STATUS SUMMARY  
TMI ACTION PLAN II.F.2  
"INSTRUMENTATION FOR DETECTION OF  
INADEQUATE CORE COOLING"

MARCH 1982

Prepared for:  
March 24th Briefing of CRGR

Prepared by:  
Core Performance Branch  
Division of Systems Integration,  
Office of Nuclear Reactor Regulation

FIGURE 6

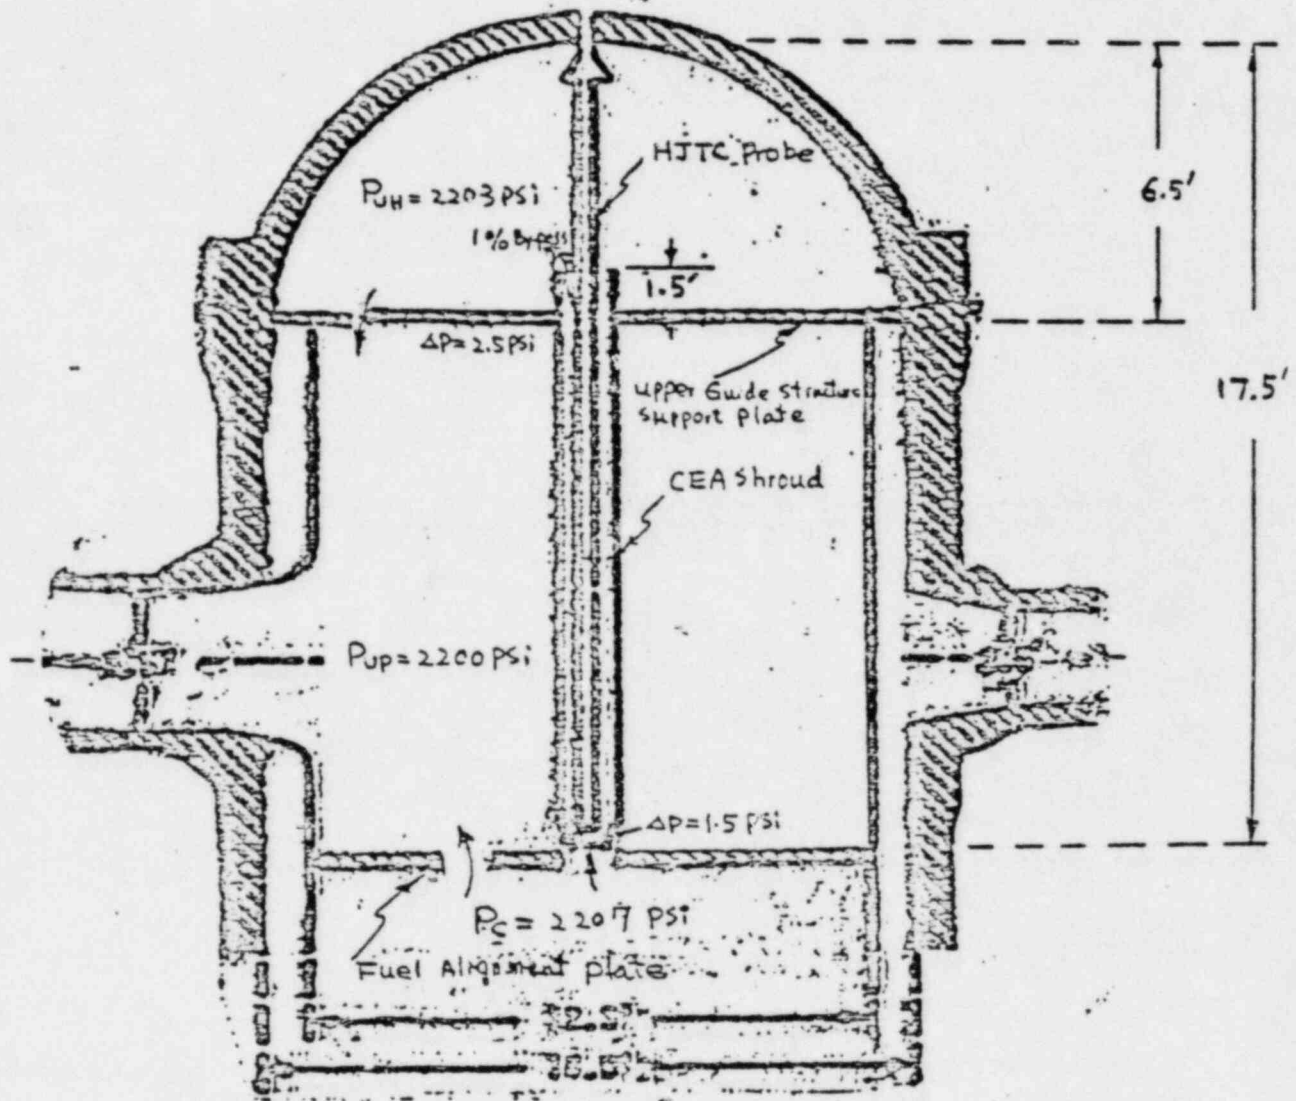
Total estimated cost for the B&W hot leg level monitoring system is 1.1 to 1.3 million dollars. However, the estimated system does not include provisions for a tap in the vessel head, as indicated by Figure 6, or for a tap in the bottom of the vessel. Therefore, we have no cost estimate for a system that has the capability to monitor level in the reactor vessel or to trend the coolant inventory with pumps running. B&W did not supply this information when asked.

- (5) It is recommended that the B&W concept (Figure 6) for monitoring hot leg level and level in the vessel head be accepted in principle without requiring a tap in the bottom of the vessel. This will not provide inventory trending capability with the pumps running.
